TECHNICAL MEMORANDUM

TO: DONALD WASHBURN, ENGINEERING
TECHNICIAN
FROM: KEITH STEWART, P.E.
MAYA VITA, E.I.T.
DATE: NOVEMBER 14, 2025
SUBJECT: PINNACLE DEVELOPMENT WATER
SYSTEM ANALYSIS
CITY OF POULSBO, KITSAP COUNTY,
WASHINGTON
G&O #25520.00

SCENARIO 2 AVAILABLE FIRE FLOW

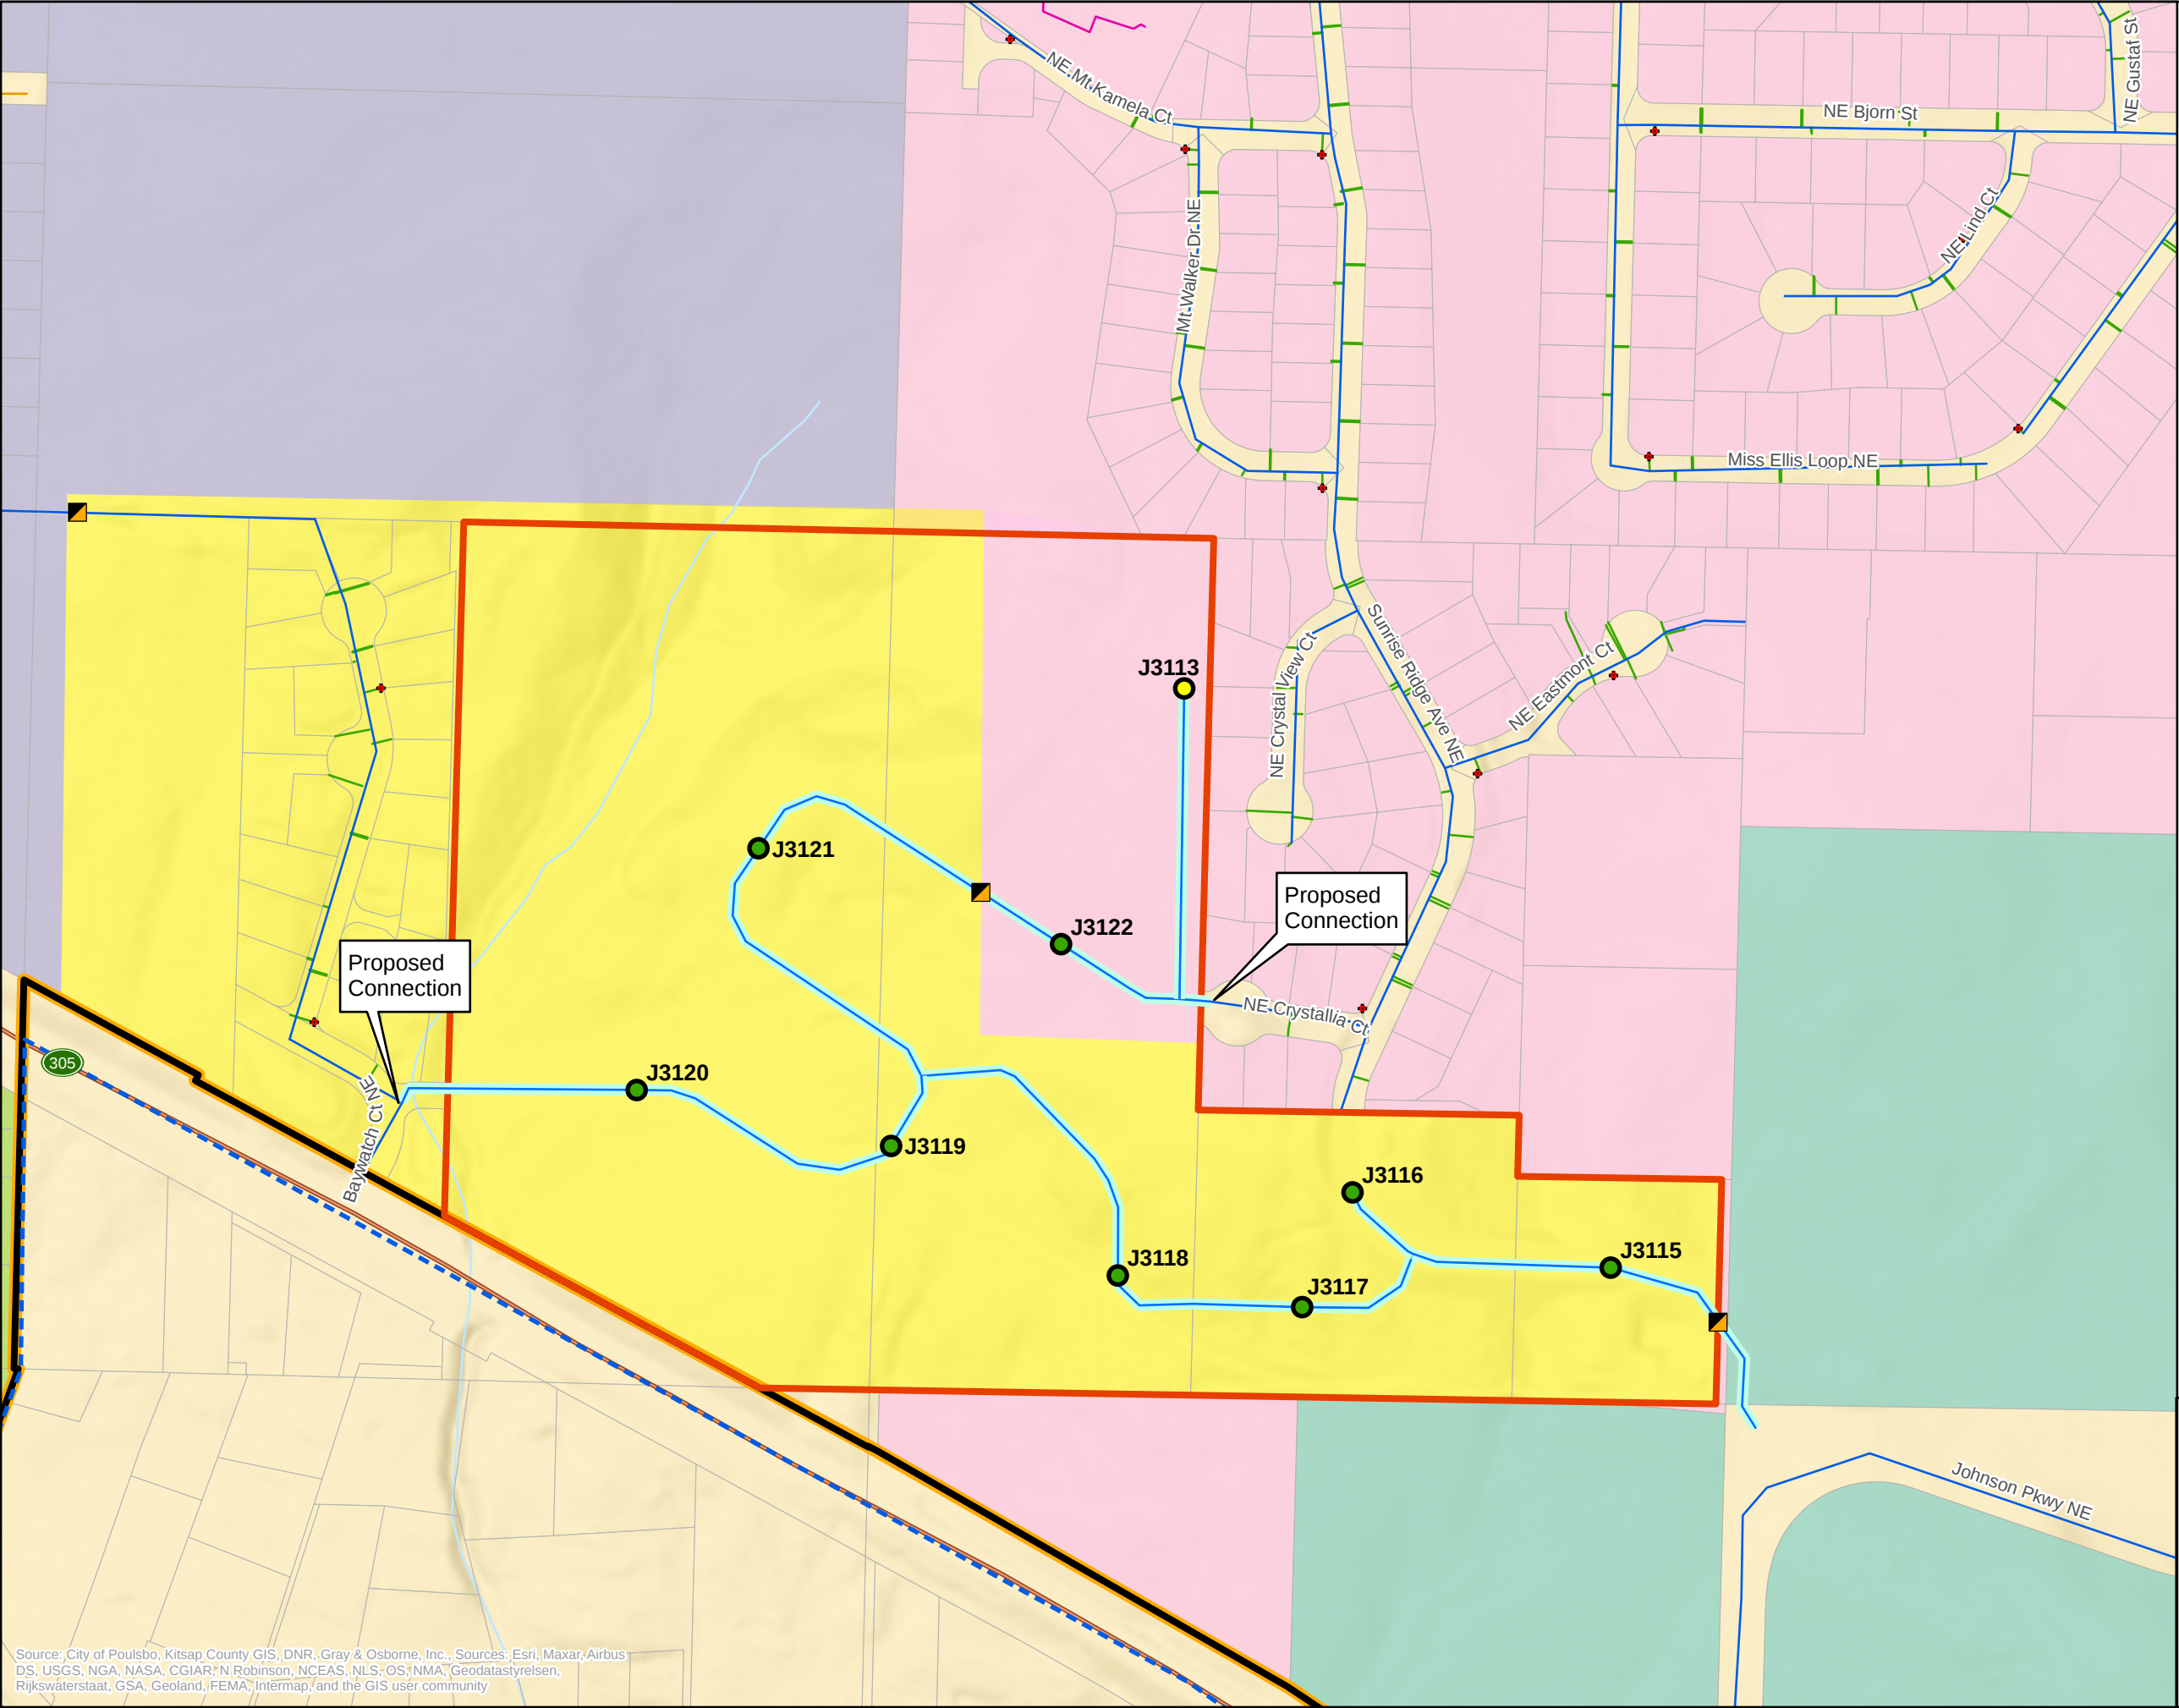
For both scenarios, available fire flow was modeled at nine proposed hydrants. These results are shown in Figure 4 and are summarized in Table 2.

The City has adopted the 2021 International Fire Code (IFC) as the minimum fire flow standard. Appendix B of the 2021 IFC, Tables B105.1(1) and B105.1(2), lay out fire flow requirements for residential buildings. For residences under 3,600 square feet, 1,000 gpm of fire flow is required if there is no automatic sprinkler system. If there is an automatic sprinkler system installed, only 500 gpm is required. Therefore, if the Pinnacle development includes an automatic sprinkler system serving all lots, the fire flow is sufficient in all scenarios. However, if there is no sprinkler system the fire flow is at least partially deficient in all scenarios.

The modeling data indicate that fire flow to the proposed hydrants would be restricted by the system pressure in the area along Sunrise Ridge Avenue. This area was found to be generally deficient in fire flow in the Draft WSP due to its high elevation, which results in a lack of available pressure. To resolve this deficiency, the Draft WSP includes a Capital Improvement Plan to add a booster pump station at Raab Park. If this booster pump station were installed, the available fire flow for the development would be greater than 1,000 gpm at all hydrants regardless of PRV placement.

SUMMARY OF RECOMMENDATIONS

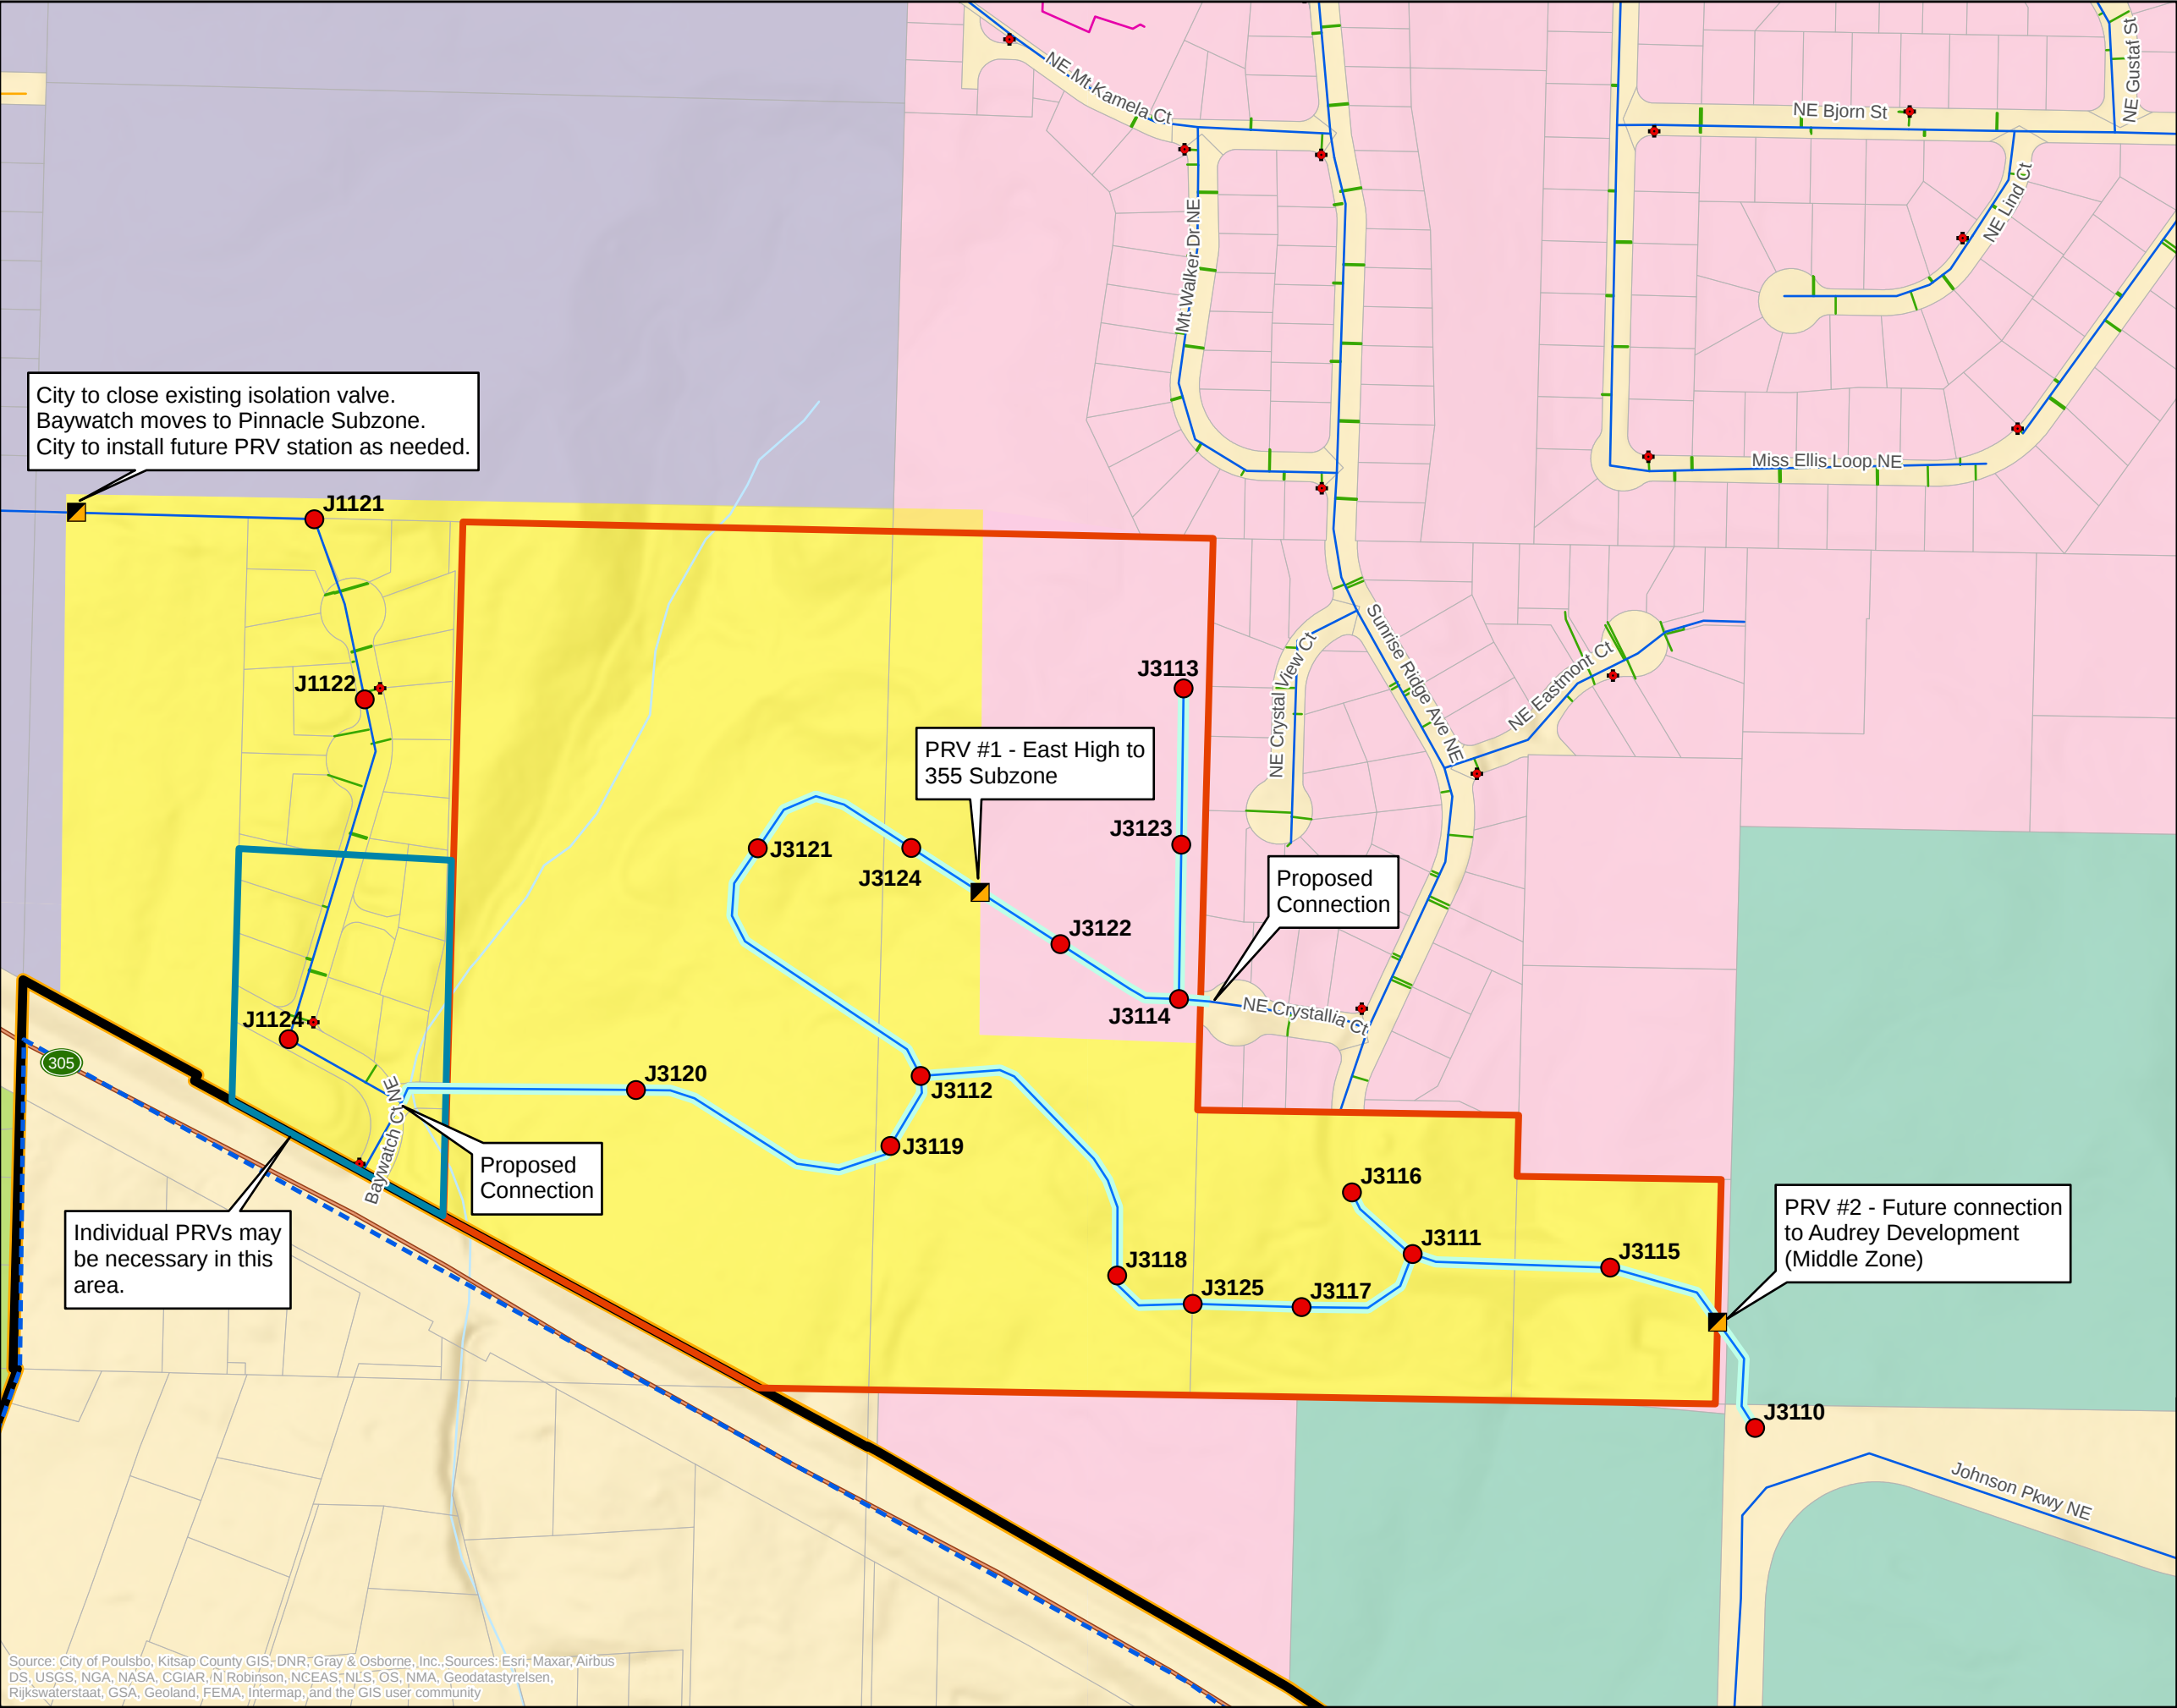
Figure 5 includes a summary of recommended modifications to the proposed development. The proposed development should include the following components.

- Connection to existing water system at Northeast Crystallia Court.
- Connection to the existing water system at Baywatch Court Northeast.
- Creation of a new Middle Subzone with an HGL of approximately 355 feet.
- Installation of a PRV station located just north of Johnson Parkway Northeast.
- Installation of a PRV station located within the proposed development, between Nodes J3122 and J3124.
- Valve closure at an existing valve west of the Baywatch Court Northeast connection.
- Installation of individual PRVs (as required) on residential properties near Node J3120.
- Installation of individual PRVs (as required) on residential properties near Node J3122.
 - Costs for the design and construction of the required PRV stations shall be borne by the Developer.
 - After construction, the ownership and management responsibility for the PRV stations would be transferred to the City.
